Manual Update Sheet

Document Being Updated: *TMS320C6000 Peripherals Reference Guide*

Literature Number Being Updated: SPRU190D

This Manual Update Sheet (SPRZ122B) describes changes for the *TMS320C6000 Peripherals Reference Guide* (SPRU190D).

Figure 6–16. Linked EDMA Transfer

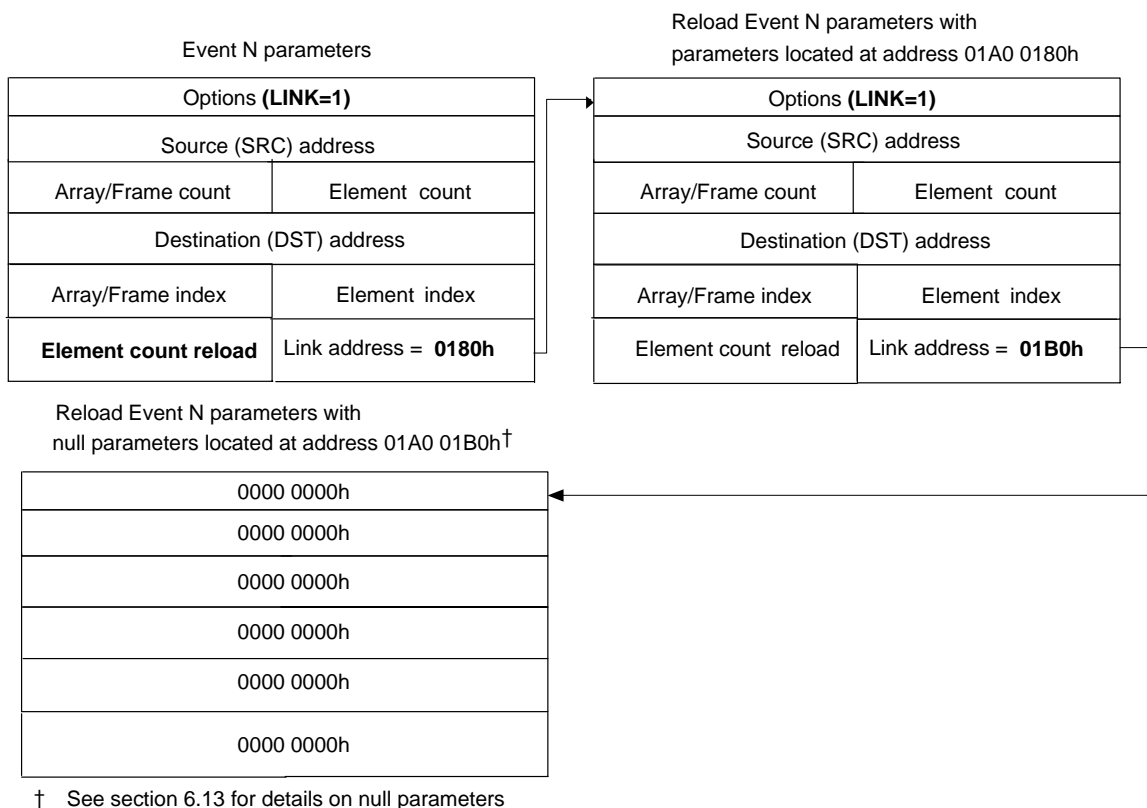
6–39 Change “Elementary count reload” to “Element count reload” in Figure 6–16:

Figure 6–17. Terminating EDMA Transfers

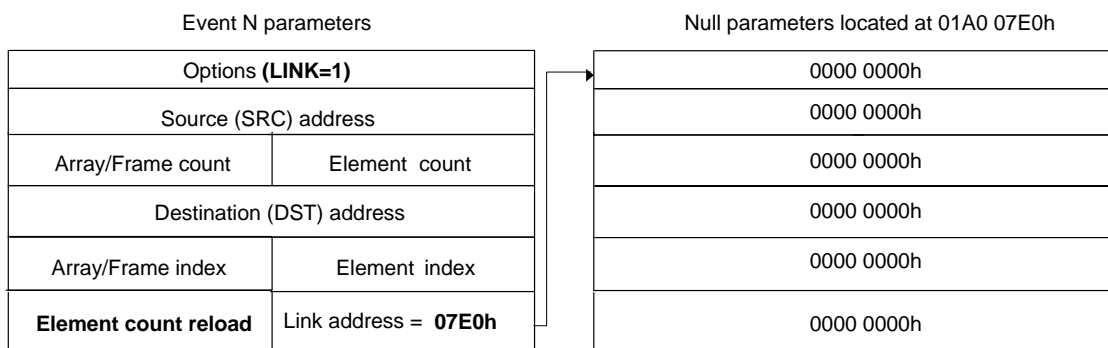
6–41 Change “Elementary count reload” to “Element count reload” in Figure 6–17:

Figure 7-13. HPI Write Timing (\overline{HAS} Not Used, Tied High) for C64x only

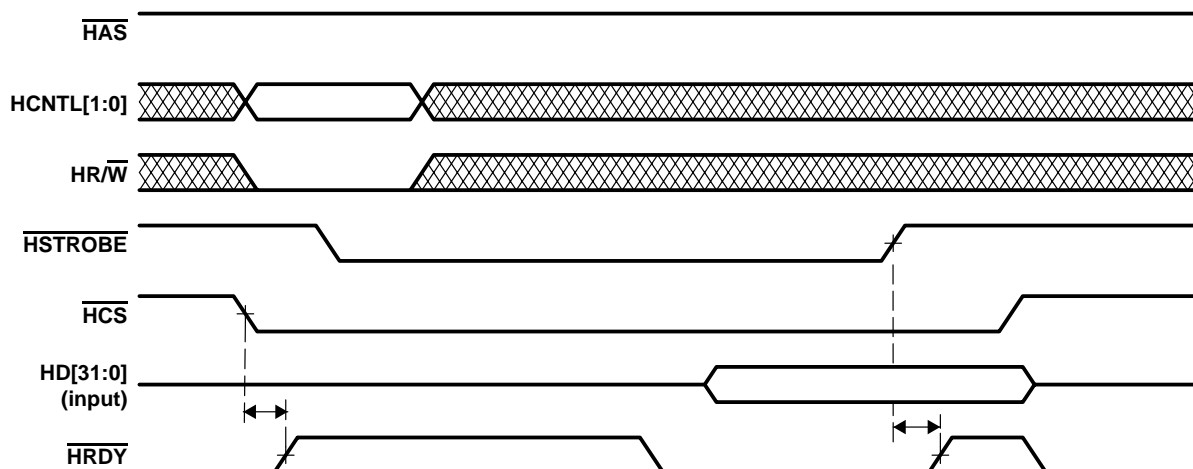
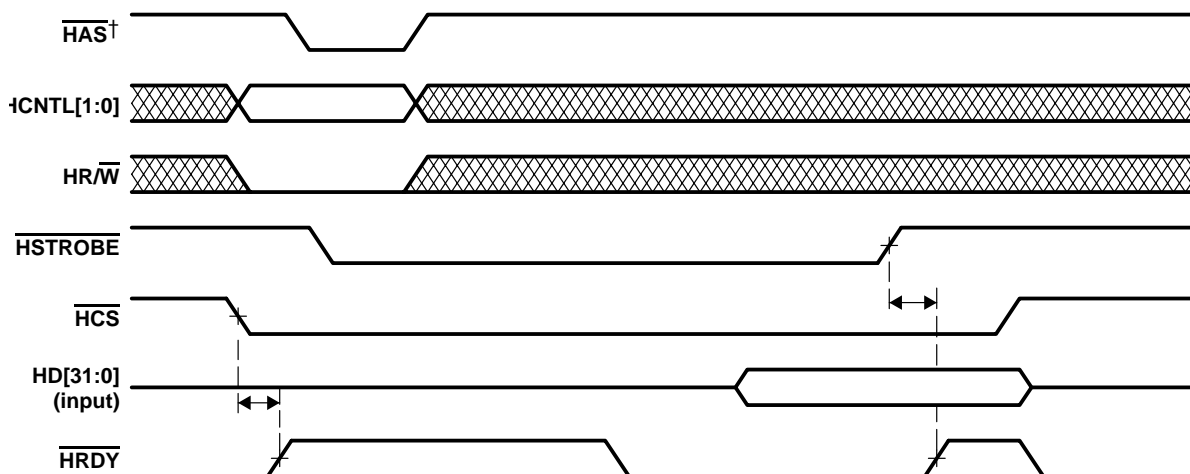
7-23 Change the HR/ \overline{W} waveform in Figures 7-13 and 7-14:

† For correct operation, strobe the \overline{HAS} signal only once per HSTROBE cycle.

Figure 8-22. Expansion Bus Master Writes a Burst of Data to the DSP

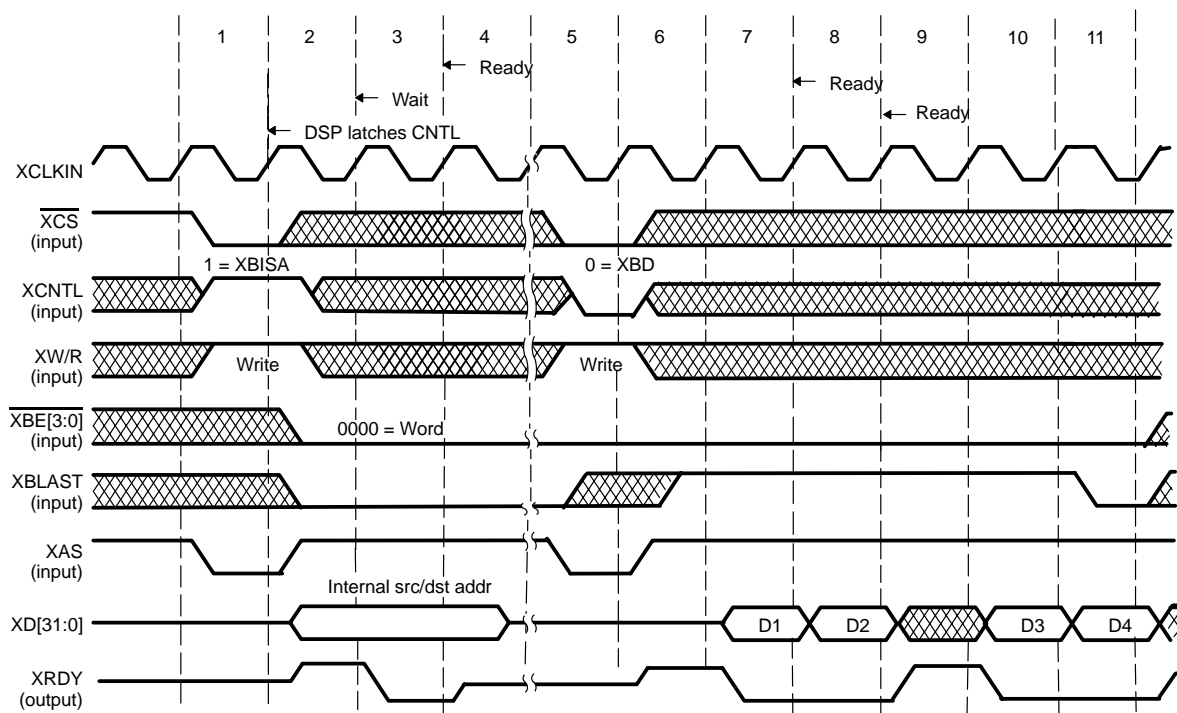
8-38 Change Figure 8-22 to show the XRDY signal in high impedance (*not* high) in clock cycle four and five. The DSP should start driving the XRDY signal during the sixth clock cycle.

Figure 8–23. The Bus Master Reads a Burst of Data From the DSP

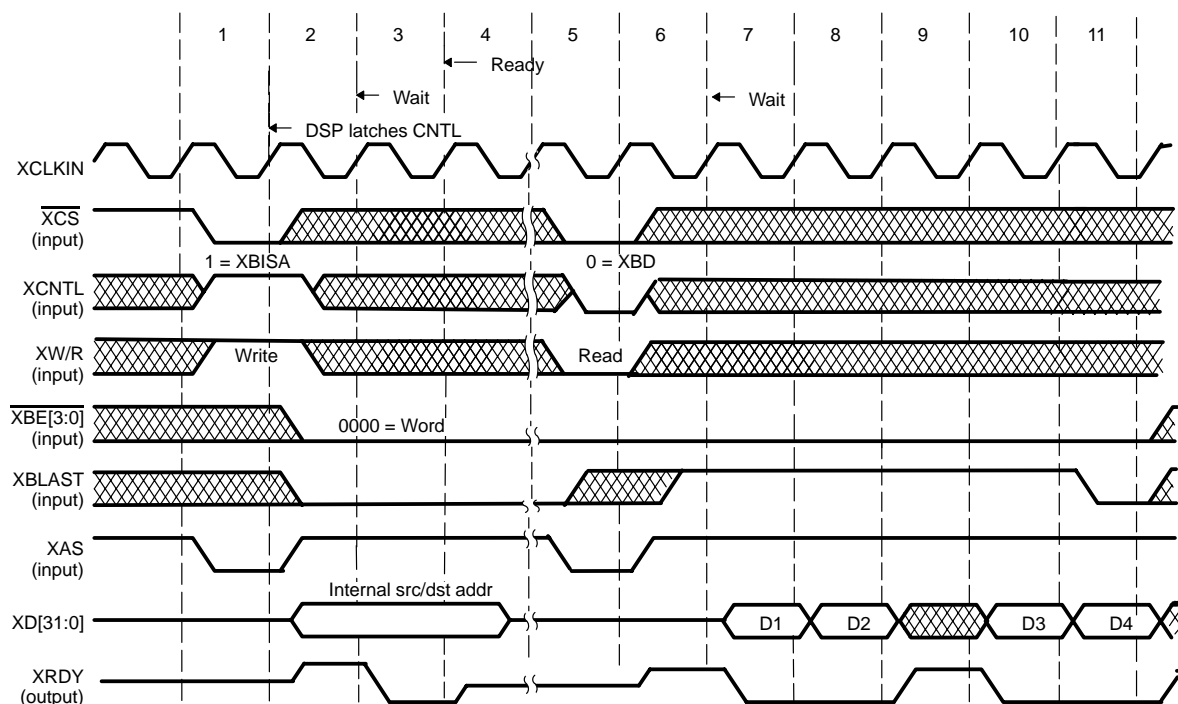
8–40 Change Figure 8–23 to show the XRDY signal in high impedance (*not* high) in clock cycle four and five. The DSP should start driving the XRDY signal during the sixth clock cycle.

Figure 10–39 TMS320C64x SBSRAM Interface

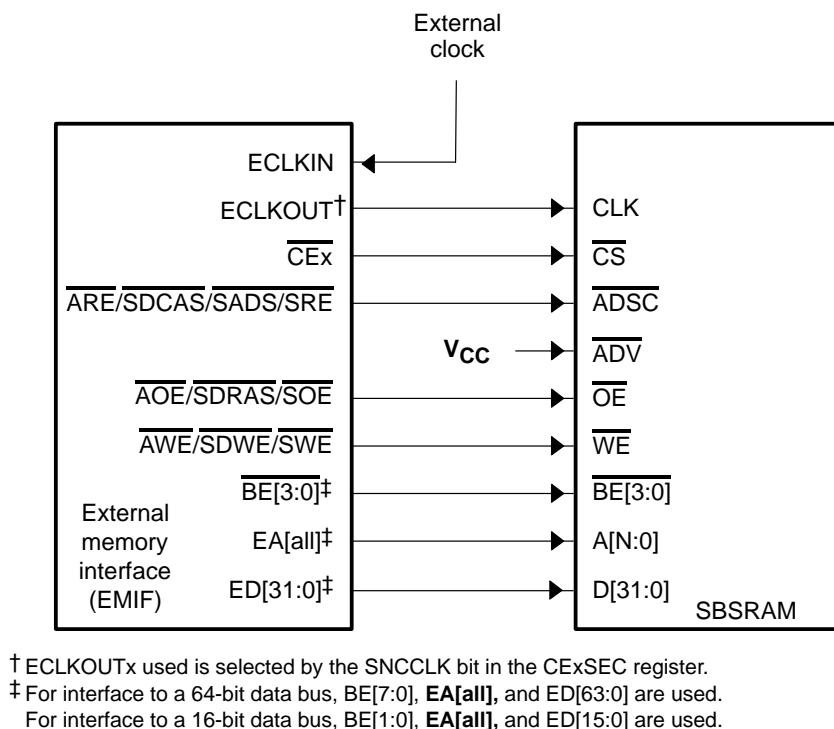
10–75 Change the input on \overline{ADV} and the footnote in Figure 10–39:

Figure 10–46. TMS320C64x ZBT SRAM Interface

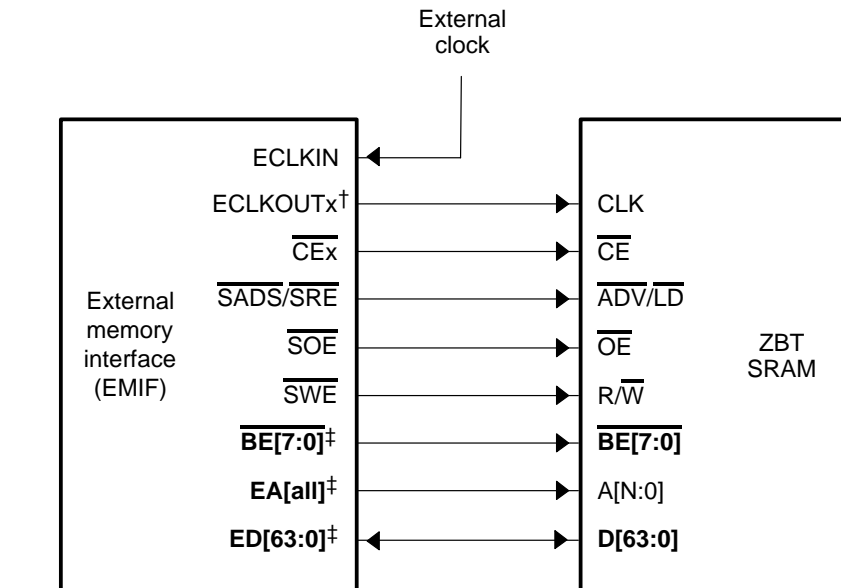
10–84 Change the signal names and footnote in Figure 10–46:

† ECLKOUTx used is selected by the SNCCLK bit in the CExSEC register.

Figure 10–47. TMS320C64x ZBT SRAM Six-Element Write

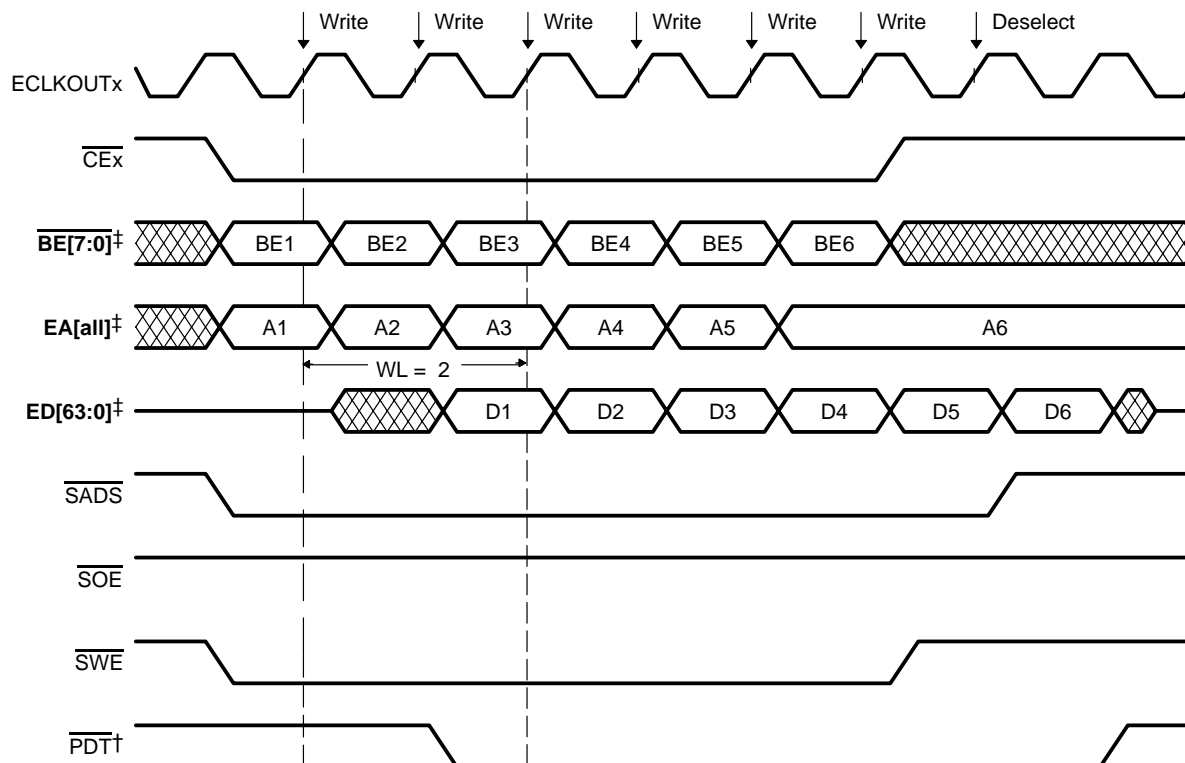
10–85 Change the signal names and footnote in Figure 10–47:

† For PDT transfers, $\overline{\text{PDT}}$ is asserted low during the data phase, and data is in high impedance. For normal read/write transaction, the $\overline{\text{PDT}}$ signal is not asserted.

‡ Figure shows 64-bit interface. The MTYPE field selects the interface type to be 8-, 16-, 32-, or 64-bits wide.

Figure 10–50. TMS320C64x Glueless Synchronous FIFO Write Interface

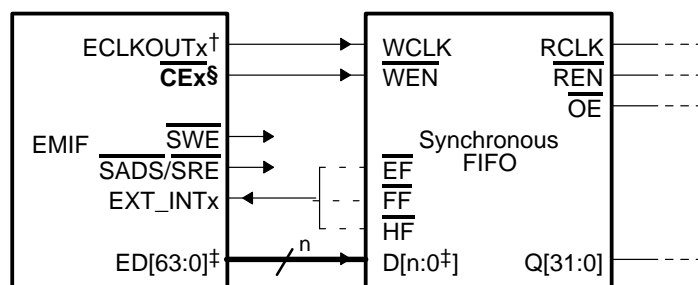
10–87 Change the figure title, signal name, and footnote in Figure 10–50:

† ECLKOUTx used is selected by the SNCCLK bit in the CEXSEC register.

Figure 10–51. TMS320C64x Standard Synchronous FIFO Read for CE0, CE1, or CE2

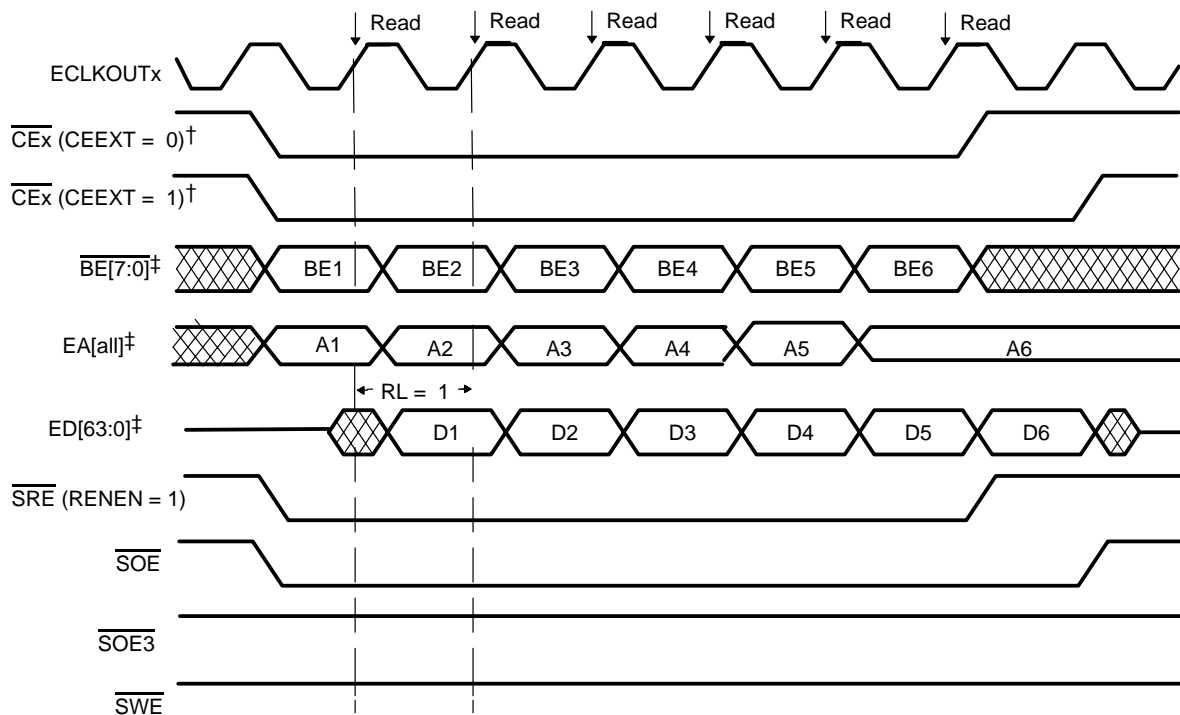
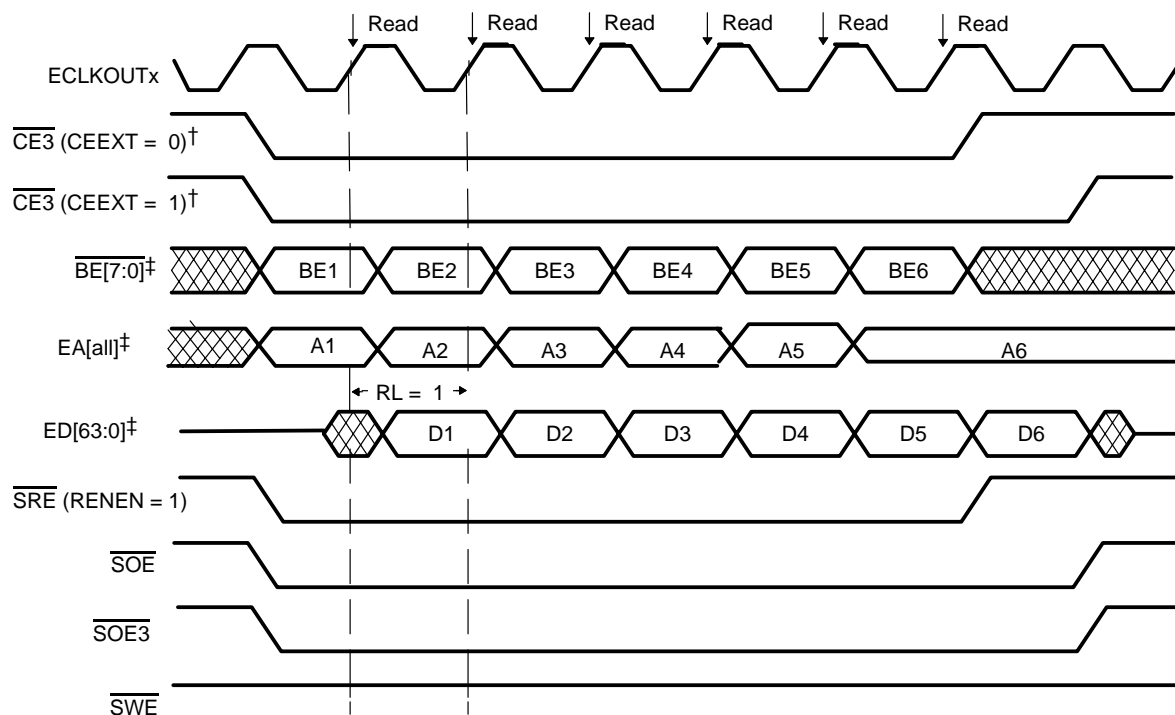
10–88 Change Figure 10–51 into two figures. The subsequent figures are renumbered accordingly:

† CEEXT = 0 for glueless synchronous FIFO interface. CEEXT = 1 for interface with glue.

† CEEXT = 0 for glueless synchronous FIFO interface. CEEXT = 1 for interface with glue.

Figure 10–53. TMS320C64x FWFT Synchronous FIFO Read

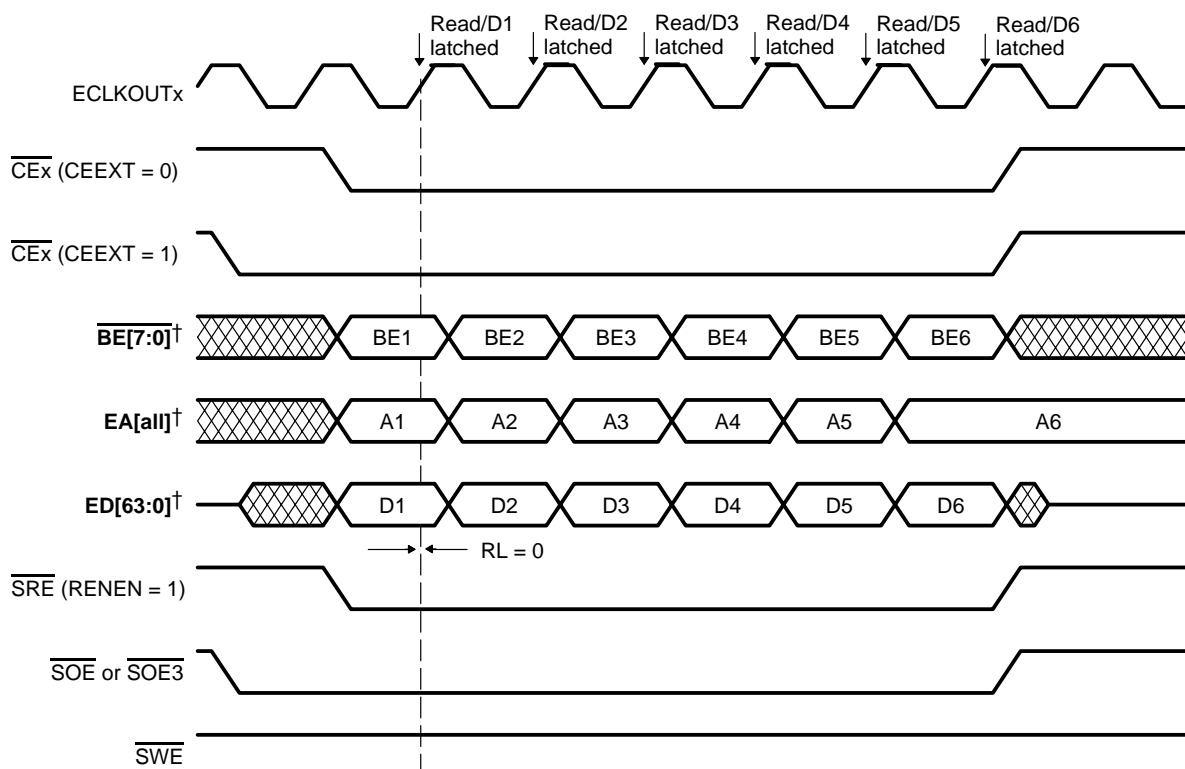
10–90 Change the signal names and footnote in Figure 10–53:

† Figure shows 64-bit interface. The MTYPE field selects the interface type to be 8-, 16-, 32-, or 64-bits wide.
 For 32-bit interface, $\overline{\text{BE}}[3:0]$, $\text{EA}[\text{all}]$, and $\text{ED}[31:0]$ are used
 For 16-bit interface, $\overline{\text{BE}}[1:0]$, $\text{EA}[\text{all}]$, and $\text{ED}[15:0]$ are used

Figure 10–65. EMIF Clock Block Diagram—TMS320C64x EMIF

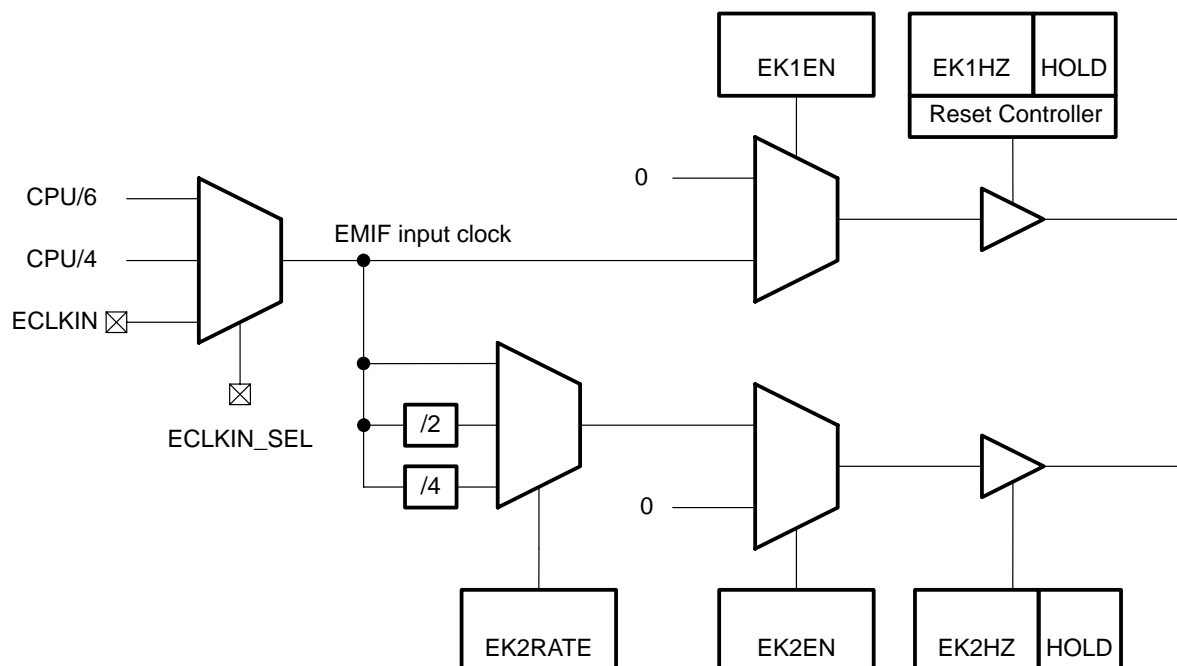
10–113 Add Figure 10–65:

For the C64x, the operation of the EMIF and device clocks is highly flexible. The CLKOUTx and ECLKOUTx can be disabled by setting the appropriate bits (CLK4EN, CLK6EN, EK1EN, EK2EN) in the EMIF global control register (GBLCTL). The ECLKOUT2 can be configured to run at 1x, 1/2x, or 1/4x the ECLKIN rate for the generic synchronous interface. In addition, the EK1HZ and EK2HZ bits in the GBLCTL configure the output EMIF clock behavior during hold. **The reset controller controls the output buffer of ECLKOUT1, ensuring that ECLKOUT1 is in a high-impedance state during device reset, see Figure 10–65.** Table 10–37 summarizes the function of the EKxEN and EKxHZ bits. See also section 10.2.1.

Figure 13–6. Timer Operation in Clock Mode ($C/\bar{P} = 1$)

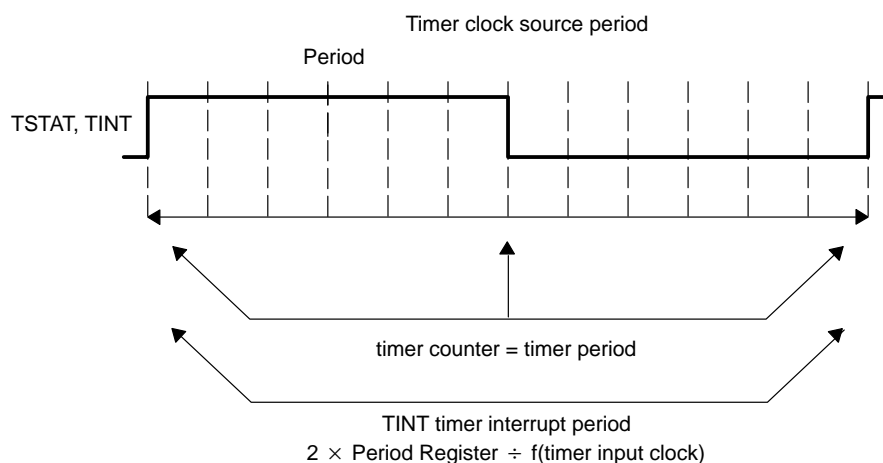
13–9 Change Figure 13–6:

Figure 17–11. GPIO Interrupt Polarity Register (GPPOL)[†]

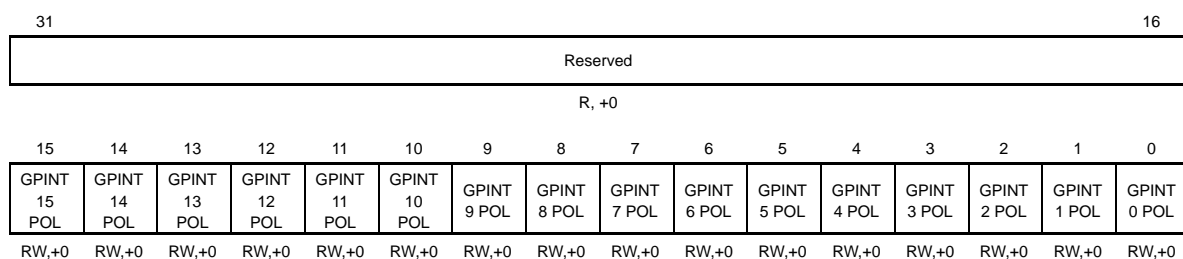
17–11 Change Figure 17–11. Add a footnote.

[†] For GPINT mapping with EDMA events and external interrupts, refer to device-specific datasheet.

Figure 18–3. UTOPIA Control Register (UCR)

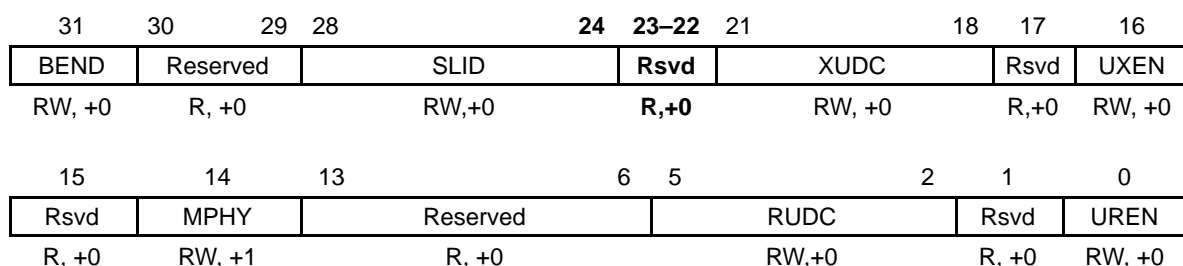
18–5 Change the SLID bit range in Figure 18–3:
